Office Action Summary

10/067,161

This is a fifth office action for serial number 10/067161, entitled Suspended Ceiling Panel Edge and Rib Technology, filed on February 4, 2002.

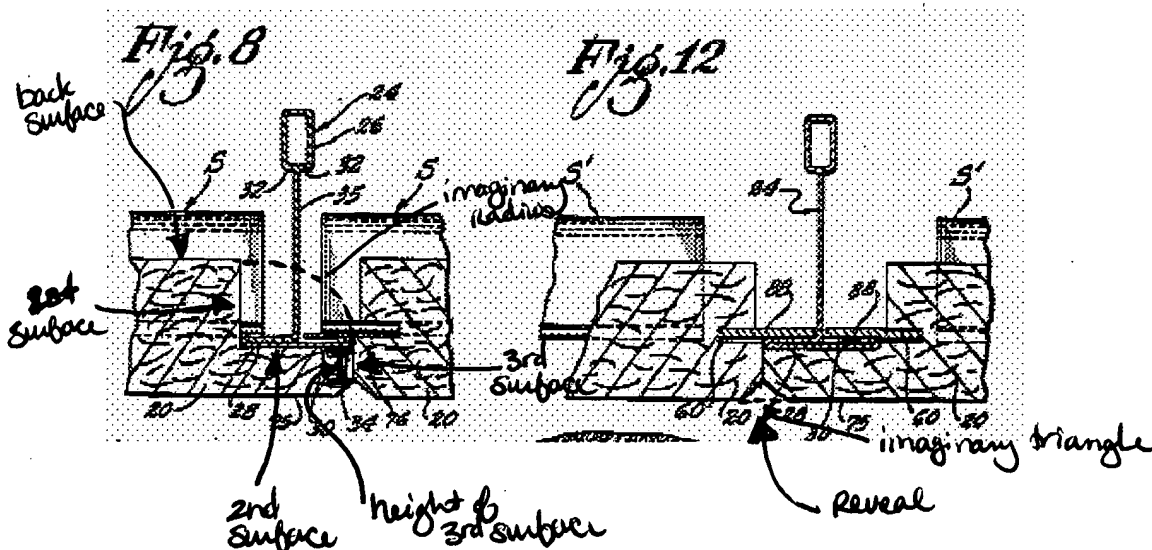
Stanley discloses the claimed invention a surface panel (20) with a major and minor dimension and a thickness dimension, a side edge of the panel corresponding to the thickness dimension, a face surface (at 75 – figure 8) of the panel facing toward a room and substantially coplanar with a plane defined by the major and minor dimensions, a back surface (see figure 8 on the next page) of the panel being opposite

of the face surface, the panel edge is multifaceted and includes a first surface intersecting the back surface (see figure 8 below), a second surface intersecting the first surface and substantially parallel to the face surface (at 75), a third surface (figure 8 below) intersecting the second surface and substantially orthogonal to the face surface, and a fourth surface (figure 3 below) intersecting and being beveled relative to the third surface, two of the surface panels (20) are located adjacent one another, the third surfaces abut without intervening framing material (figure 8), and the fourth surface is arranged so as to represent a surface of a triangularly grooved reveal (figure 12 below); the fourth surface intersects the face surface (at 75); the first surface is substantially orthogonal to the back surface (figure 8); the surface panel is a ceiling panel for suspended ceiling (shown in figure 10); the surface panel is a wall panel (interpreting the ceiling to be a wall); a height of the third surface is about half of the distance between the second surface and the face surface (see figure 8 below); the fourth surface is a continuous surface (by continuing into the face surface and the third surface); the third surface is more outboard, relative to an imaginary radius (figure 8 below) extending from a center point of the panel and sweeping out an imaginary plane

substantially parallel to the back surface, than the first surface; the first, second, third and fourth surfaces together present a generally convex conformation (figure 8); the fourth surface is substantially planar (figure 8).
